Bid Bulletin #4

PROJECT: York General Hospital Addition/Renovation

DATE: March 5th, 2014

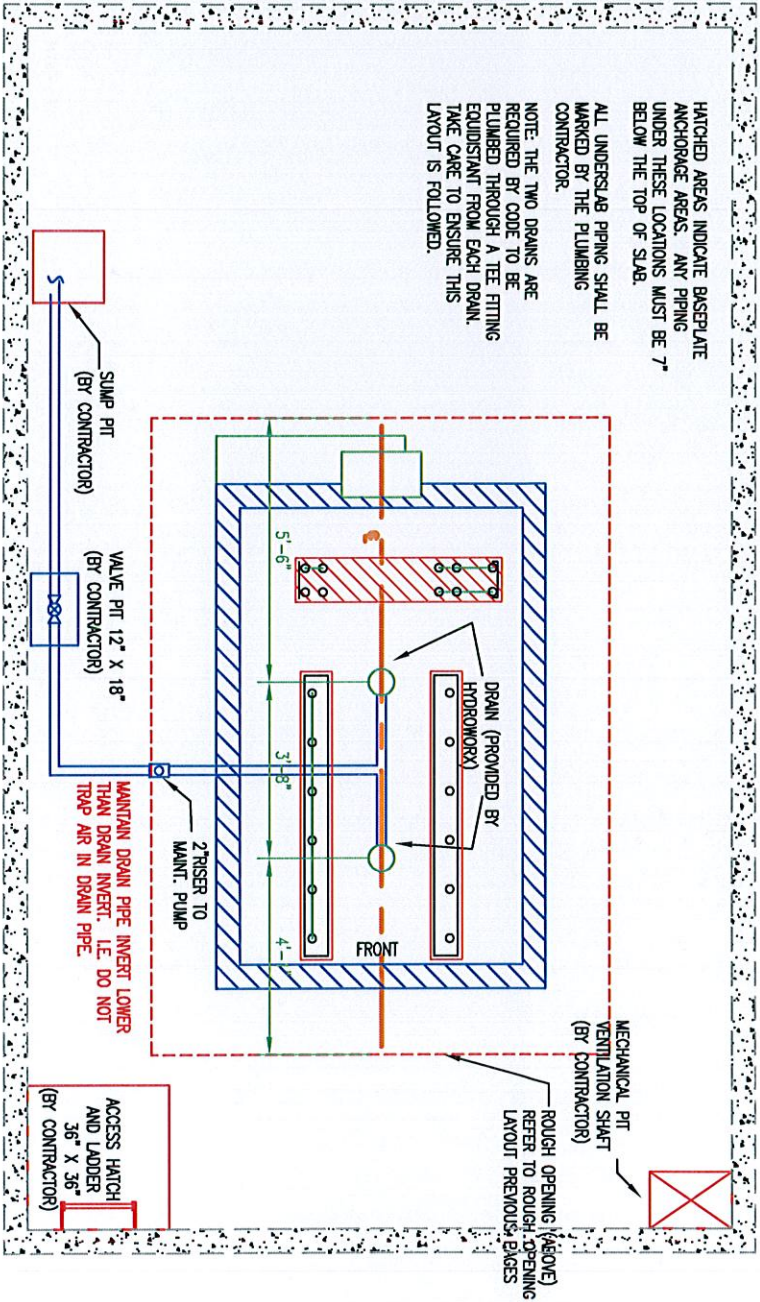
Item 4-6 See attached Hydropool drawings- Contractors are required to get Connections to pool. Final connections will be by pool installer.

Demolition Plan

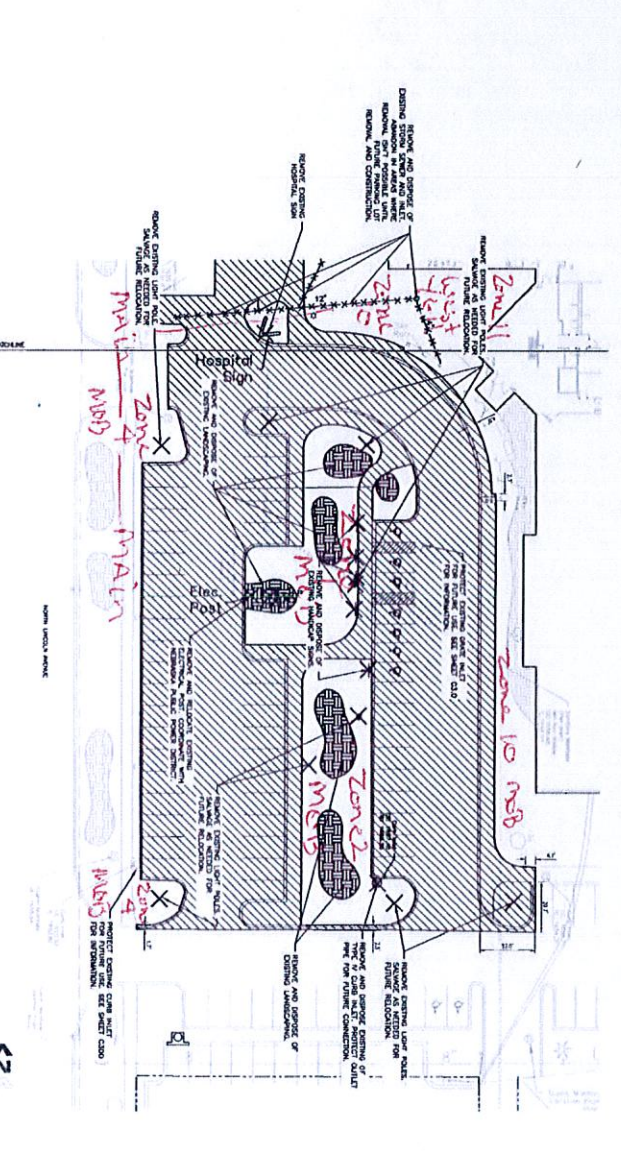
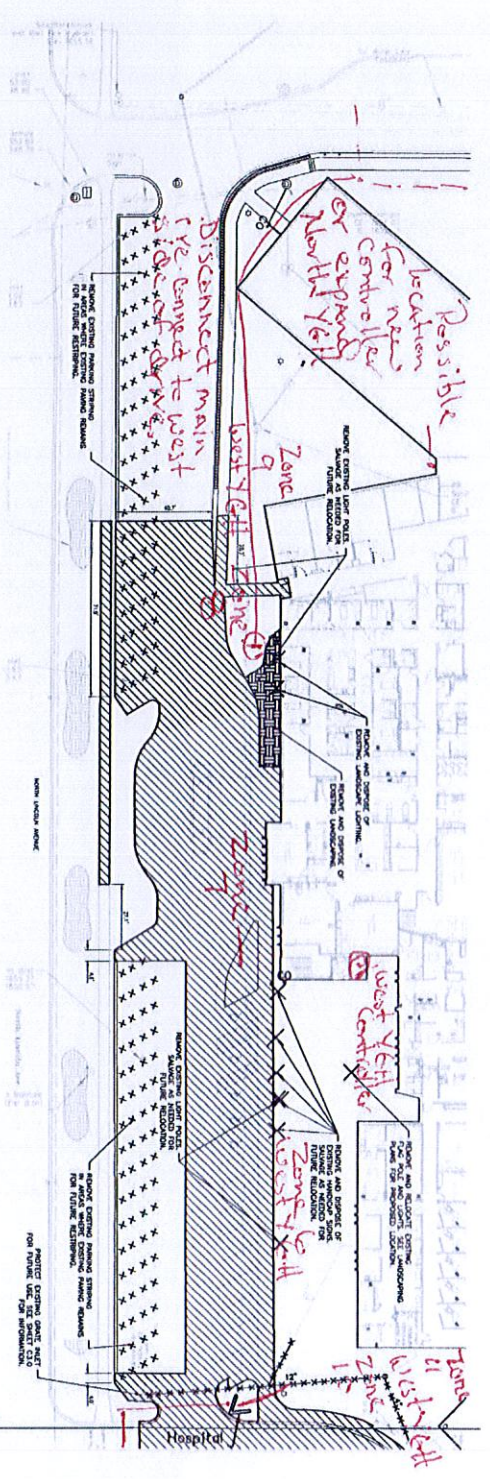
Item 4-7 Exterior sprinkler drawings- Attached are head sketches of what is existing along the west side of YGH. Areas not being affected by construction must be kept operational to reduce plant loss.

Notes: Existing 2" Main runs around perimeter of bld. Will need to cut and run line to west side of drive. A new 2" main should be anticipated along west side of hospital up to middle acces off Lincoln Ave. West YGH controller will need to be relocated or North YGH controller will need to be added to.
